**BOARD OF ZONING ADJUSTMENT
STAFF REPORT****Date: June 1, 2015**

<u>CASE NUMBER</u>	5980/5668
<u>APPLICANT NAME</u>	Donald Blocker
<u>LOCATION</u>	4512 Higgins Road (Northside of Higgins Road, 230'± West of Shipyard Road.)
<u>VARIANCE REQUEST</u>	SITE: Site Variance to allow a gravel laydown yard for postal trucks in a B-3, Community Business District.
<u>ZONING ORDINANCE REQUIREMENT</u>	SITE: The Zoning Ordinance requires asphalt, concrete, or an approved alternative paving surface for vehicle parking and maneuvering for commercially utilized building sites.
<u>ZONING</u>	B-3, Community Business District
<u>AREA OF PROPERTY</u>	120,432 square feet/2.76 ± Acres
<u>TRAFFIC ENGINEERING COMMENTS</u>	No traffic impacts anticipated by this variance request. Owner/developer have already indicated that gravel surface will not extend into right-of-way, and that driveways are to be improved.
<u>ENGINEERING COMMENTS</u>	If the aggregate surfacing is approved for use the applicant will need to have the following conditions met: <ul style="list-style-type: none">a. Submit and receive a TIER 2 Land Disturbance Permit for the proposed site development through Central Permitting.b. Submit a ROW

SITE PLAN

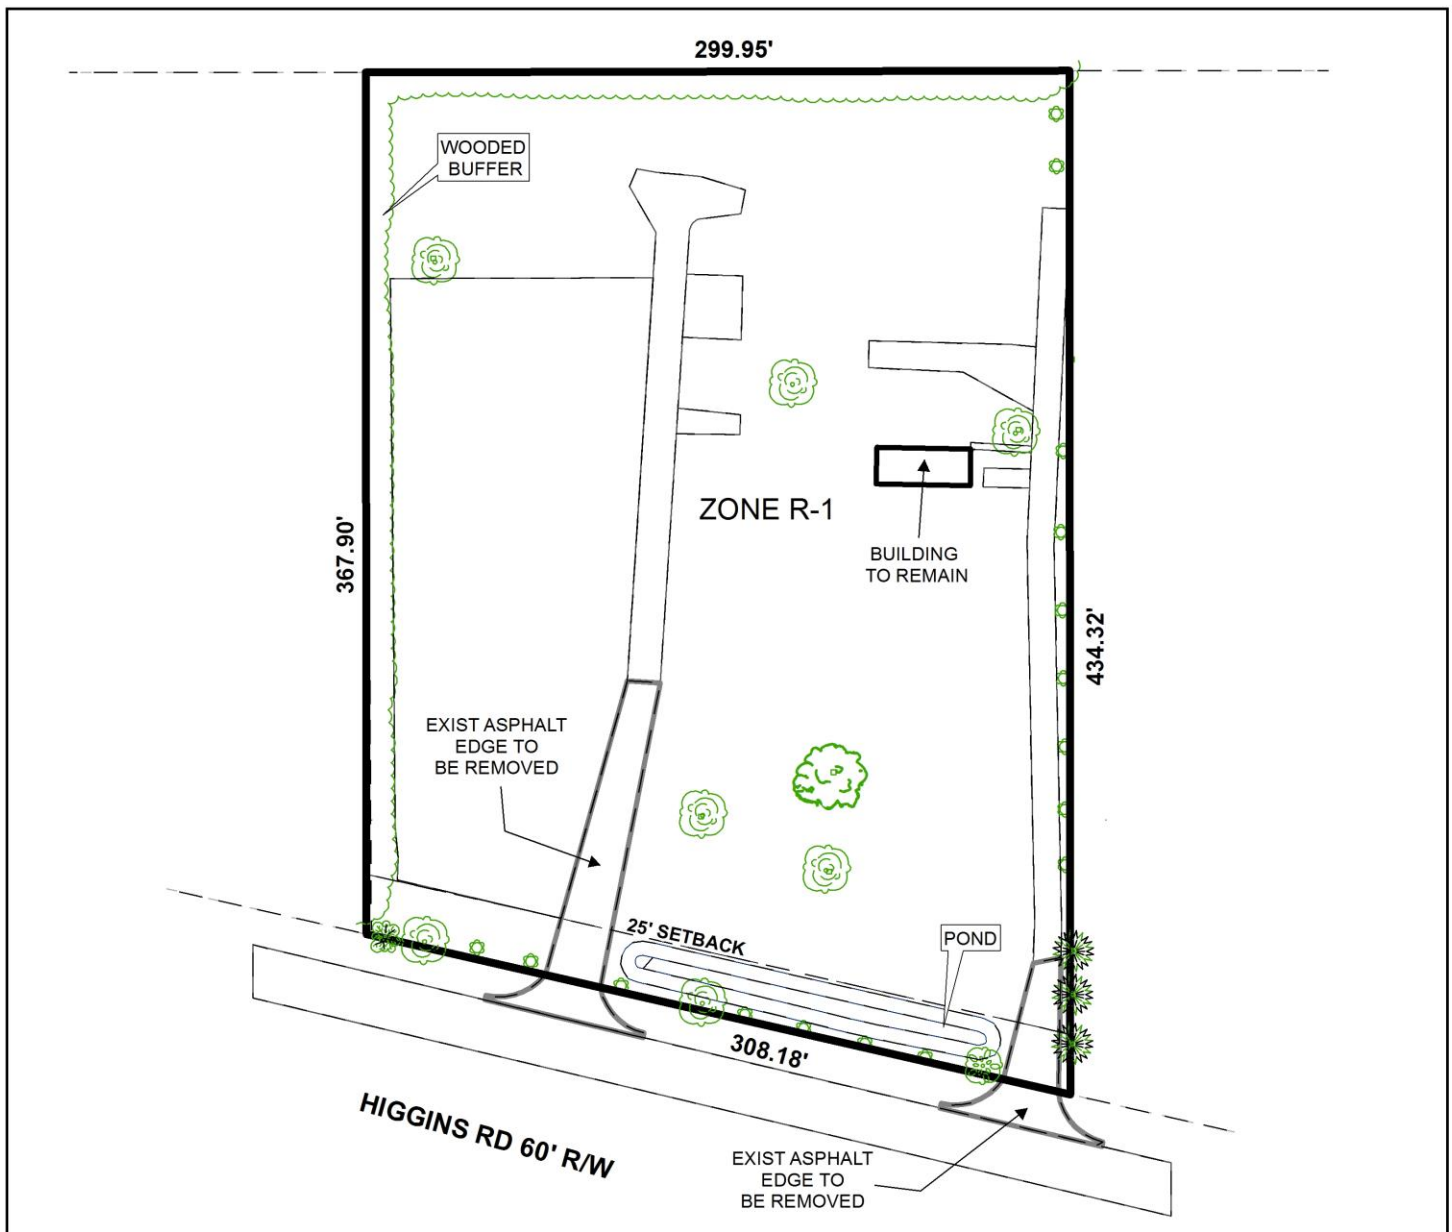
Upon review of the site plan, and as stated by the applicant, the gravel surfacing will only be used on the western portion of the site and that the business will only be open during normal business hours. These considerations would appear to lessen the proposed use's impact to the site, and with appropriate buffering and landscaping its visibility from the street. It also appears that the remaining areas of the site will remain untouched with alterations and improvements to be completed in accordance with the Zoning Ordinance.

The applicant states that the improvements made to the site, such as upgrading and carrying the existing asphalt driveway into the site and providing compliant landscaping, will be completed; however, there are revisions that need to be addressed on the site plan in order to bring the property into full commercial site compliance. For instance, the site plan illustrates a compliant driveway and apron adjacent to the truck parking area; however, the secondary driveway, adjacent to the existing building to remain, is only depicted as 11.65' in width and should be revised to reflect a minimum width of 24' to allow two -way access. Also, the parking table on the site plan indicates that three parking spaces are required and will be provided for the site per the Ordinance; however, the site plan should be revised to illustrate each parking space, and provide the required length and width dimensions of the spaces in addition to wheel stops or curbing. Wheel stops, landscape timbers, or similar should be used to define the boundary of the entire gravel area in order to prevent vehicular encroachment into required buffers or into unimproved portions of the site.

On-site lighting should be provided in accordance with Section 64-6.A.3.c of the Ordinance. The applicant indicated on the site plan that garbage collection will be curb-side via a private collection service; this note should be retained on the site plan if approved.

The site plan should also be revised to illustrate compliant landscaping as required by Section 64-4.E of the Ordinance. The perimeter understory tree plantings should illustrate the required number of trees to be provided on site; the existing wooded buffer cannot be substituted in lieu of the 37 required perimeter tree plantings unless a sufficient number of existing trees are identified by size and species to be claimed for the credits. The applicant also acknowledges the existence of the residential property located to the east of the subject site and stated that they would retain or provide a buffer in compliance with zoning regulations.

In addition to providing a suitable and compliant buffer/screening between the residential and proposed commercial site, the applicant should ensure that appropriate screening, in compliance with Section 64-4.D of the Zoning Ordinance, is provided along both the side and rear property lines of the area of the property that contains the postal truck storage. Also, screening should be provided on the portion of the site near the street frontage. A privacy screen should be provided setback 10' from the front property line and may consist of a 3'-5' tall berm or evergreen planting 3'-5' tall at the time of planting, or it may consist of a 6' privacy fence to shield the site from the view of the general public located at least 25 feet from the front property line.

The site fronts Higgins Road, a paved minor street without curb and gutter. Higgins Road requires a 60' right-of-way width. The plan depicts the existing right-of-way width as 60' and should be retained on the revised site plan, if approved.

The 25' minimum setback line is also depicted on the plan and should be retained on the revised site plan, if approved.

As a means of access management, a note should be placed on the revised site plan stating that the site is limited to the two curb-cuts to Higgins Road, with the size, design, and location to be approved by Traffic Engineering and conform to AASHTO standards.

- 1) Approval by the City Council to allow the property to be rezoned from R-1, Single Family Residential District to B-3, Community District;
- 2) Revision of the site plan to update the secondary driveway, adjacent to the existing building to remain, to reflect a minimum width of 24' as required by Section 64-6 of the Zoning Ordinance for a two-way drive;
- 3) Revision of the site plan to illustrate each required parking space, and provide the required length and width dimensions of the spaces in addition to wheel stops or curbing, as required by Section 64-4.E of the Zoning Ordinance;
- 4) Provision of on-site lighting in accordance with Section 64-6.A.3.c of the Ordinance;
- 5) Retain or provide a buffer in compliance with Sections 64-4.D of the Zoning Regulations;

- 6) Revision of site plan to reflect compliance with the landscaping and tree planting requirements of Section 64-4.E of the Zoning Ordinance as applies to frontage and perimeter trees;

- 7) Retention of the note on the revised site plan stating that garbage collection will be curb-side via a private collection service;
- 8) Provision to retain and/or provide a buffer between the subject site and the residential property located to the east of the subject site in compliance with Section 64-4.D of the Zoning Ordinance;

- 9) Provision of screening along the rear and side property lines of the outside storage area in compliance with Section 64-4.D of the Zoning Ordinance;

- 10) Provision of screening setback 10' from the front property line in the form of a 3 to 5 foot high berm or evergreen hedge, or a 6 foot high privacy fence setback 25 feet from the front property line;

- 11) Retention of the 60' right-of-way width at Higgins Road;
- 12) Retention of the 25' minimum setback line on the revised site plan, if approved;
- 13) Placement of a note on the revised site plan stating that the site is limited to the existing curb-cuts to Higgins Road, with the size, design, and location to be approved by Traffic Engineering and conform to AASHTO standards;

- 14) Obtainment of land disturbance, right-of-way, building, and other necessary permits prior to the start of site improvements;
- 15) Provision of wheel stops, landscape timber, or other similar devices to prevent the encroachment of vehicles into any required buffers or onto any unimproved areas of the site;

- 16) Provision of revised site plan illustrating compliance with the conditions prior to any requests for permits; and
- 17) Full commercial site compliance, and compliance with all other municipal codes and ordinances.
